STANDARD INSPECTION · KITCHEN AND APPLIANCES · SAMPLE REPORT

# Kitchen and built-in appliances

| PROPERTY   | 3-room apartment, new build<br>Tallinn, Kristiine district ·<br>address removed | INSPECTION | 02.09.2026, 10:00–12:40<br>duration 2 h 40 min                                      |

PHOTO 2.1 · EXTRACT JOINT INSIDE THE CABINET

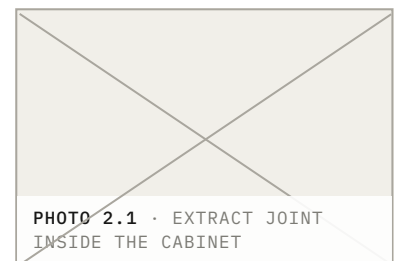
## Hood extract unsealed, mounted lower than required

The joint between the extract duct and the hood flange has no seal or clamp; the duct is simply placed on the flange. The bottom edge of the hood is 620 mm above the hob, while the manufacturer requires at least 650 mm above an electric hob.

Seal the joint with a clamp or aluminium tape and raise the hood to the height required by the manufacturer. Ask the contractor to cite the relevant point of the installation manual.

| 02 | Seal the hood extract joint and bring the hood height into line with the<br>manufacturer's manual. FINDING 2             | BEFORE FINAL PAYMENT |

PHOTO 3.1 · CABLE BETWEEN THE CASING AND THE WALL

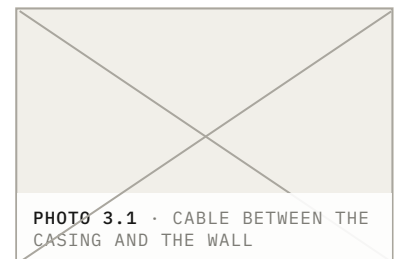
## Socket behind the dishwasher is inaccessible

The plug is connected to a socket behind the appliance that cannot be reached without pulling the machine out. The supply cable is pressed between the appliance casing and the wall. The manufacturer's manual requires the plug to be accessible without removing the appliance.

Move the socket to the adjacent cabinet (side panel of the sink cabinet) or fit an accessible isolator switch. Route the cable so that it is not trapped between the casing and the wall. Work to be done by an electrician.

| 03 | Move the dishwasher socket to an accessible position or fit an isolator switch.<br>Work by an electrician. FINDING 3     | BEFORE FINAL PAYMENT |

PHOTO 4.1 · BRACKET POSITION UNDER THE WORKTOP

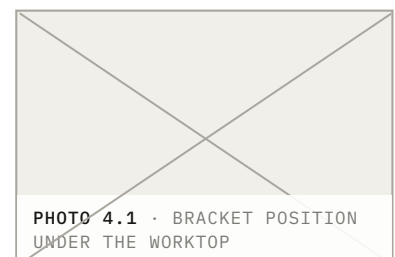
## Dishwasher is not fixed to the worktop

The appliance has been pushed into the opening, but the manufacturer's fixing brackets to the worktop or side panels have not been fitted. When the door is opened and the lower basket pulled out, the machine tilts forward by about 5 mm.

Fix the appliance with the supplied brackets according to the manual, adjust the feet and check that it is level.

| 04 | Fix the dishwasher with the manufacturer's brackets and level it. FINDING 4                                              | BEFORE FINAL PAYMENT |

## No ventilation opening behind the oven

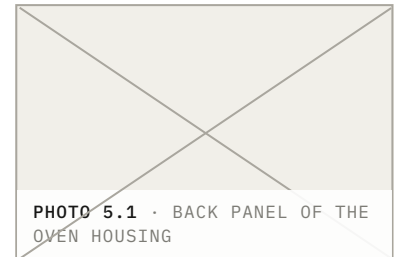
The back panel of the oven housing is solid; the manufacturer requires a ventilation opening in the back panel and an air inlet in the plinth. During the heating test (30 min, 200 °C) the surface of the adjacent front reached 47 °C.

Cut the ventilation opening in the back panel as specified by the manufacturer and provide an air inlet through the plinth (grille).  
Re-check the front temperature after the repair.

| 05 | Cut the ventilation opening in the oven housing and fit the plinth grille as<br>specified by the manufacturer. FINDING 5 | BEFORE FINAL PAYMENT |

## Scratch on the edge of a drawer front

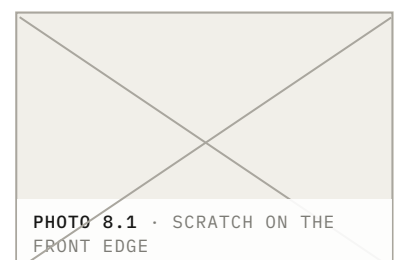
There is a scratch about 20 mm long on the top edge of the front, going through the paint layer. The other fronts are undamaged.

Replace the front or agree a price reduction. Touch-up paint is not a lasting solution on a matt-lacquered front.

| 08 | Replace the scratched drawer front or agree a price reduction. FINDING 8                                                 | BY AGREEMENT         |

## Plinth end panel not fixed

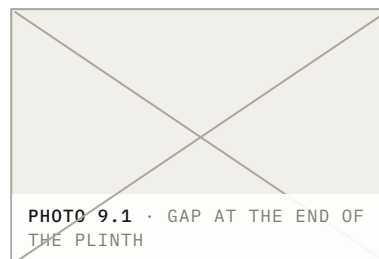
The plinth end panel is not fixed with a clip and stands with a 6 mm gap; it moves when touched.

Fit a plinth clip and cut the panel to the exact size.

## Tile grout missing around a socket

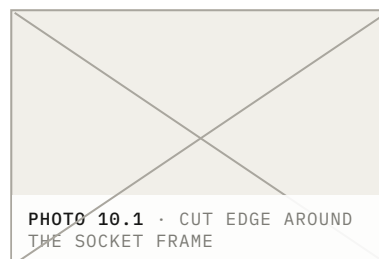
The cut edge of the tile is visible around the socket frame and grout is missing over about 40 mm; the frame covers the gap only partly.

Fill the joint with grout or cover it with a wider frame (as agreed with the client).
